February 11, 2013

## **SAFETY RECALL NOTICE – SAYFLINK SLEEVE** **Immediate Action Required**

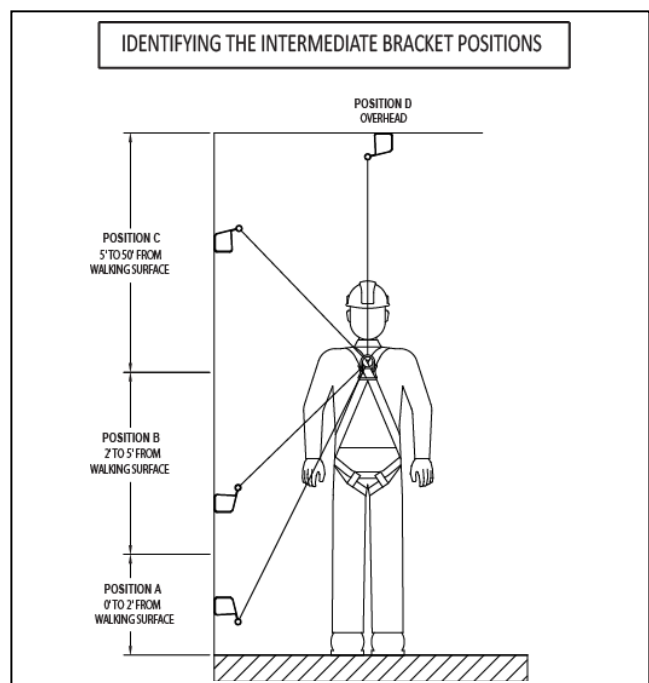
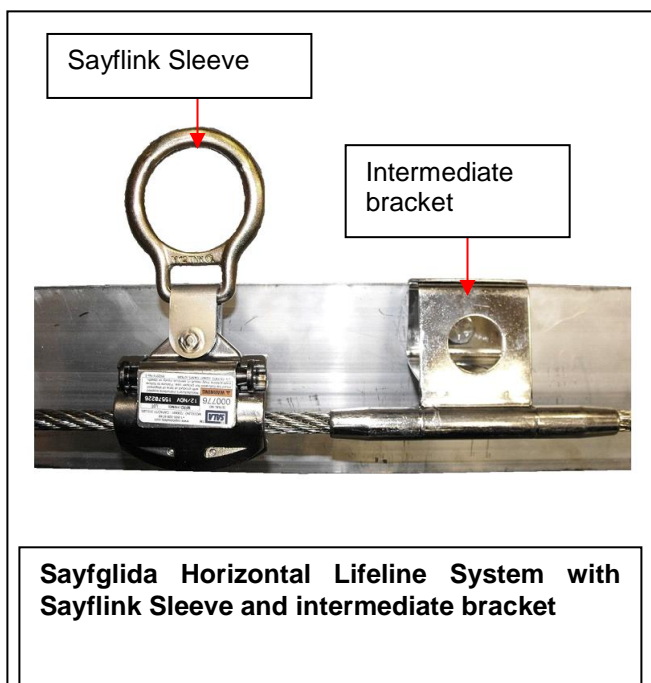
The reason for the recall is that, when the intermediate brackets are installed at walking surface level (between zero and two feet above the walking surface as illustrated in Position A below), there is a remote possibility that the sleeve can disengage from the cable as it slides over an intermediate bracket while trailing a worker moving across the walking surface. See “Identifying the Intermediate Bracket Positions” below.

Although Capital Safety’s testing shows the Sayflink Sleeve is safe to use in bracket positions B, C and D as illustrated above (and any height between these positions), out of an abundance of caution, Capital Safety is recalling all Sayflink Sleeves regardless of the height of the permanently installed brackets.

If you have Sayflink Sleeves in service that were manufactured after May 2004, you should immediately take the sleeves out of service and call our Customer Service department at 1-800-328-6146 to arrange to return the sleeve. Capital Safety will repair or replace the sleeve dependent upon the specific needs of the end user. This will be done at Capital Safety’s expense. The free replacement applies only if the returned sleeve is in proper working condition as determined by Capital Safety; if not, charges may apply.
